External Decking

Site sections

1 Alder Rise, Whaley Bridge

1116.06

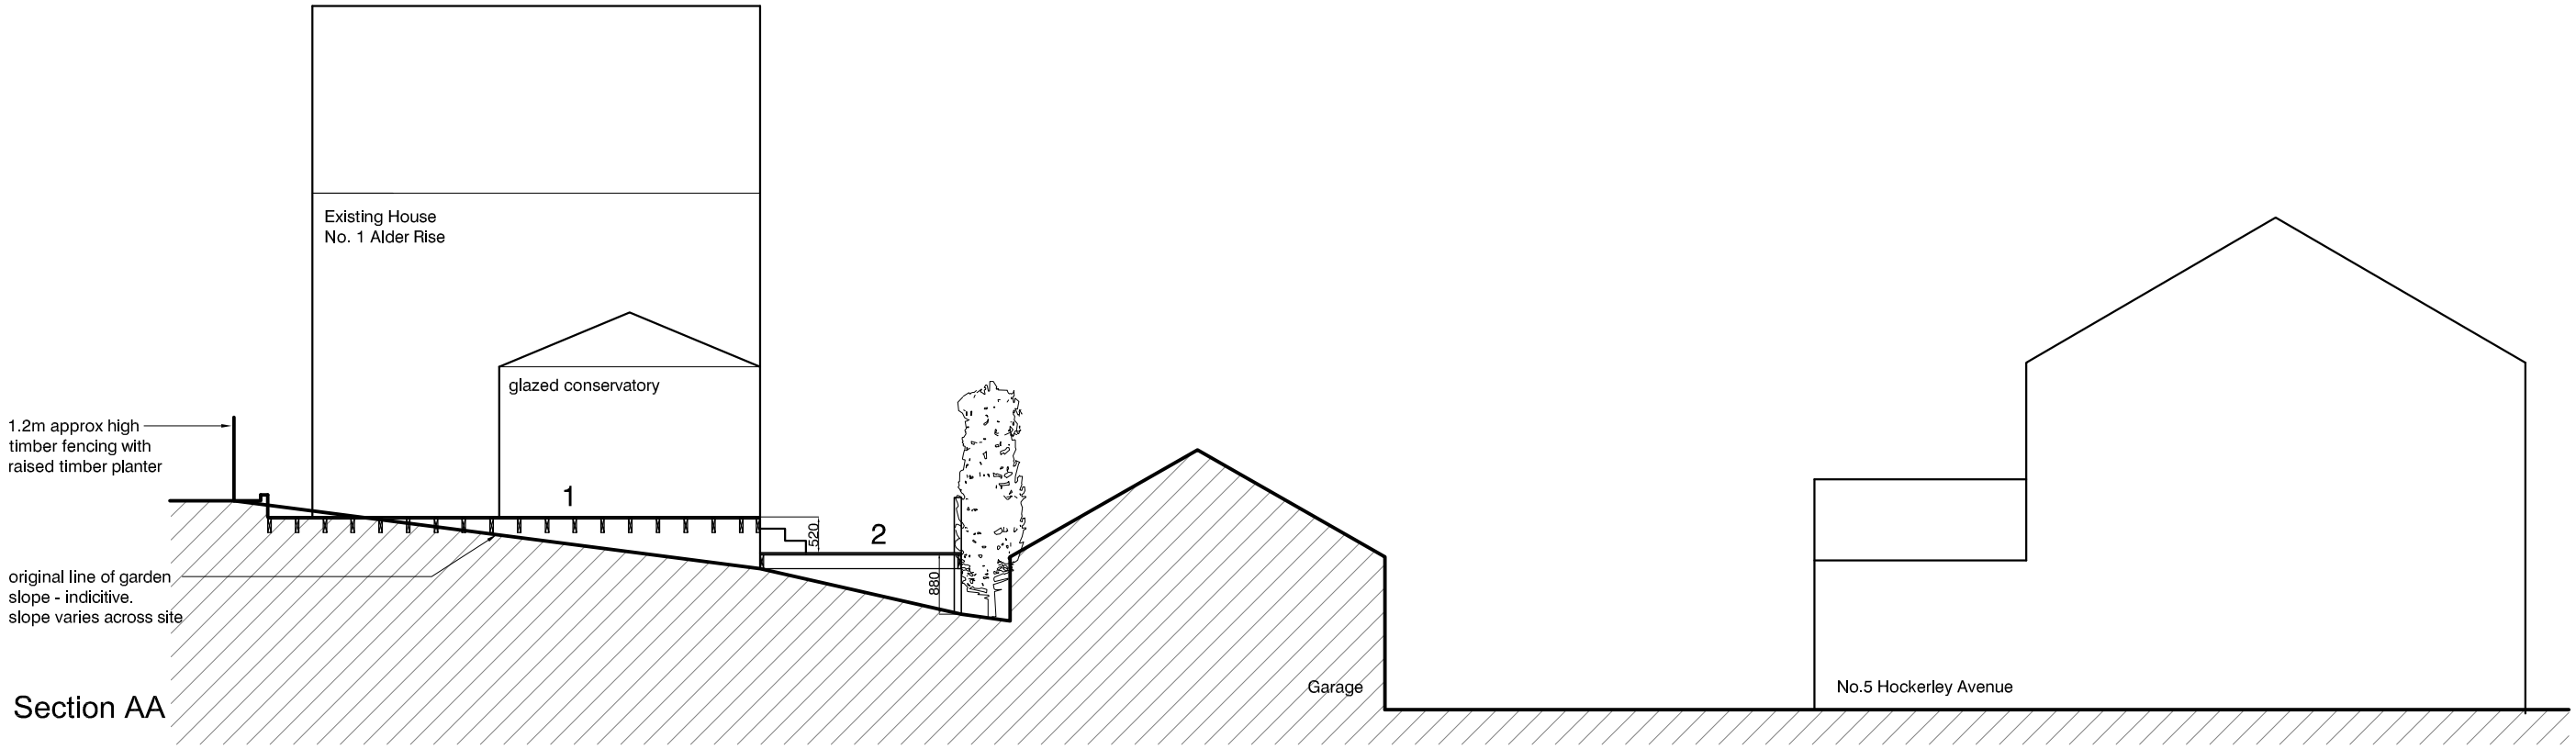
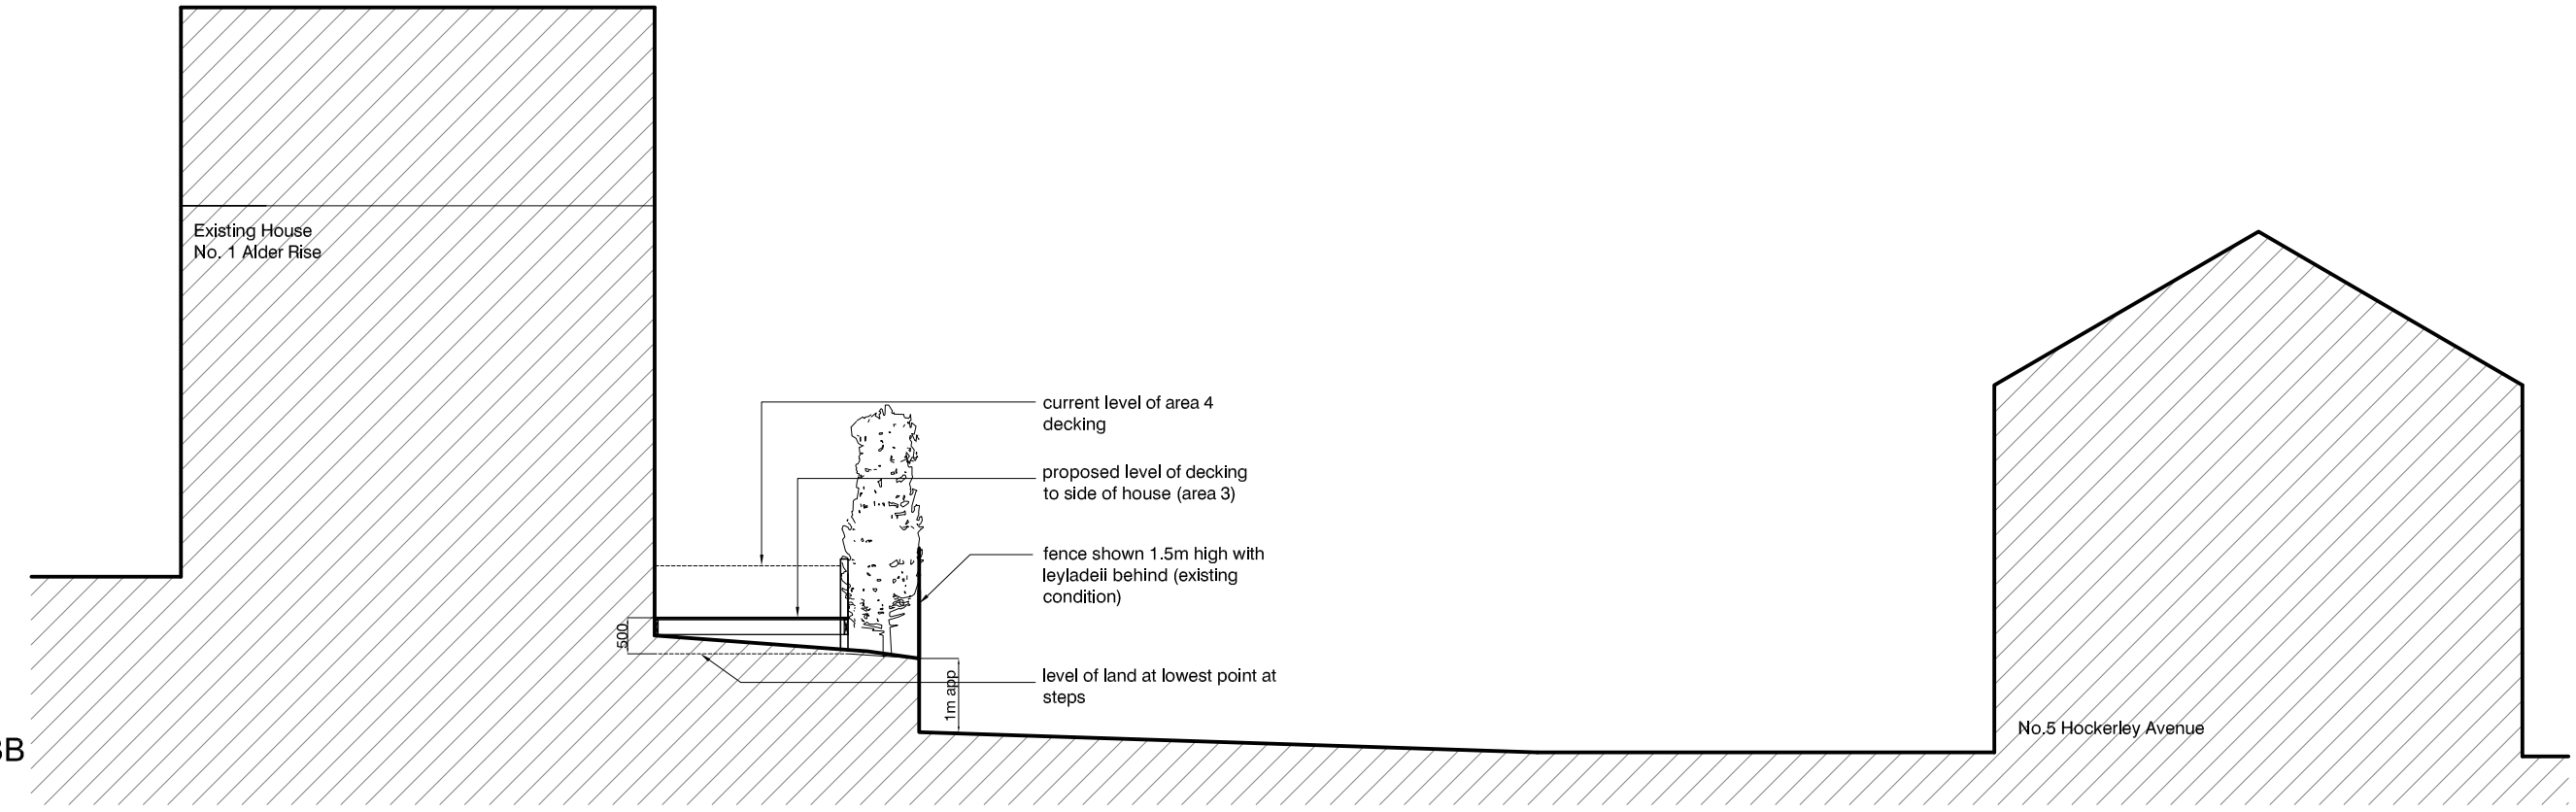
Revised proposal:
Sections of decking 3 and 4 reduced in height by 600mm below what is currently the level of section 3. This is the lowest it can be taken without removing earth from underneath.
Section 1 and 2 remain the same as the current condition as neither can be dropped any further.
The safety fencing is shown as current - however the client would be amenable to a close boarded fence to a height of 1.8m if required.
